ACV-P54-06 Drilled Washer - 0.75":

AeroConversions		
Rotax Drilled Washer - 0.75"		
Drawing Scale 2X	Drawing Number ACV-P54-06	Revision A

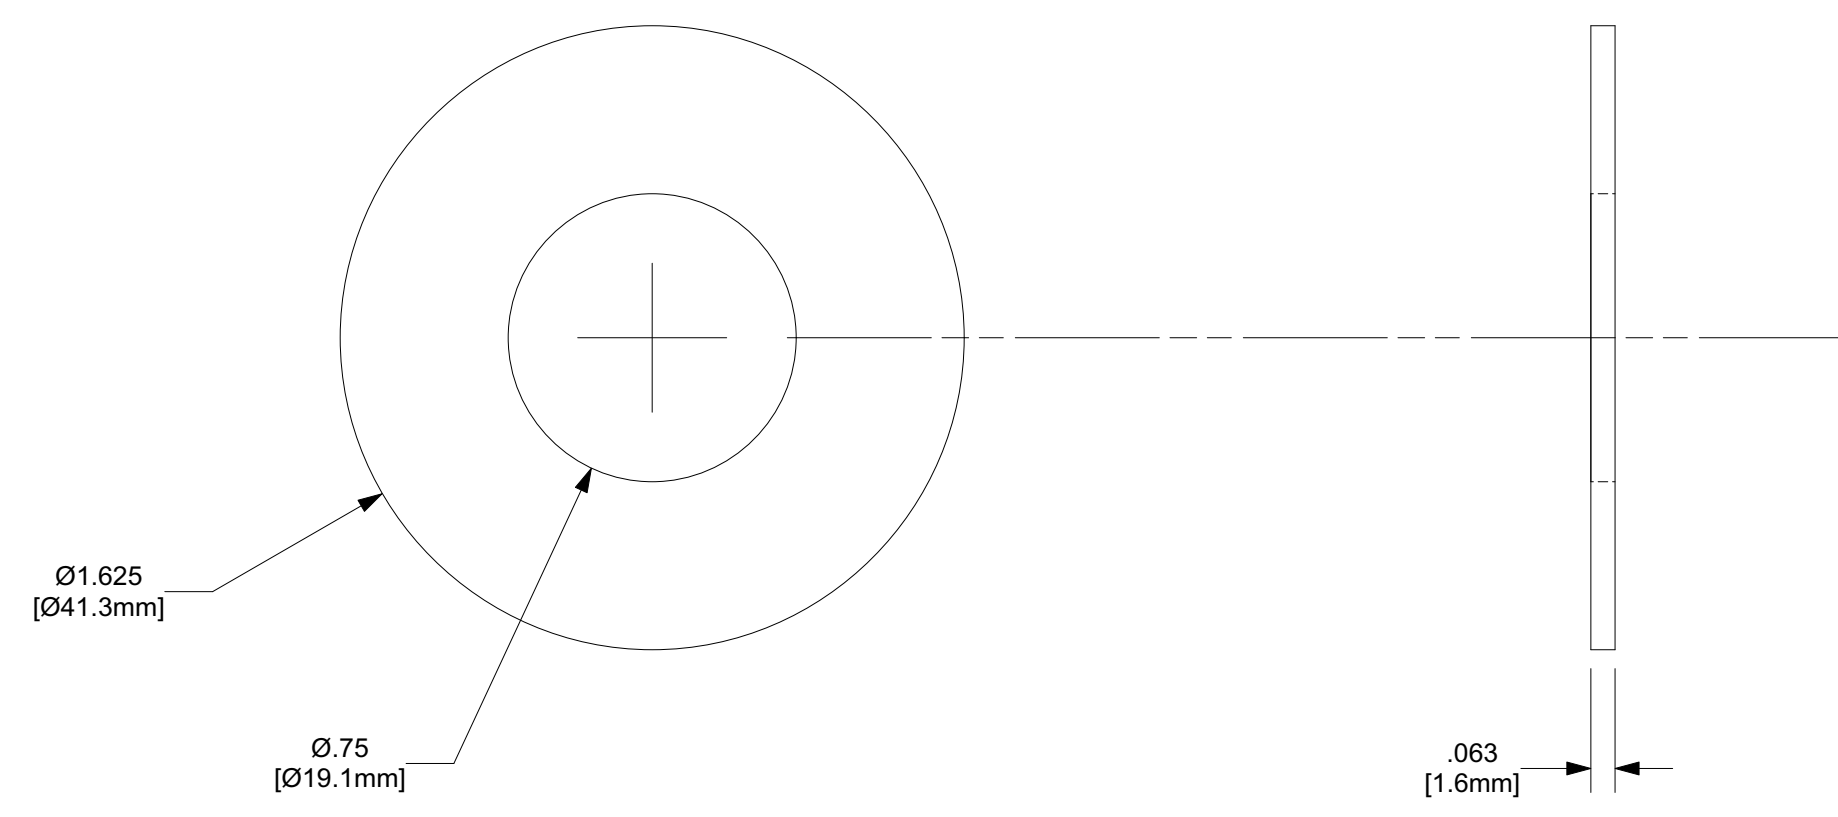
Revision Letter	Change Description	Date
A	Corrected Washer Specification from AN970-5 to AN970-6	08/29/23

Make From AN970-6 1.625" OD x 0.390" ID x 0.063 Thick Cad Plated Steel Washer
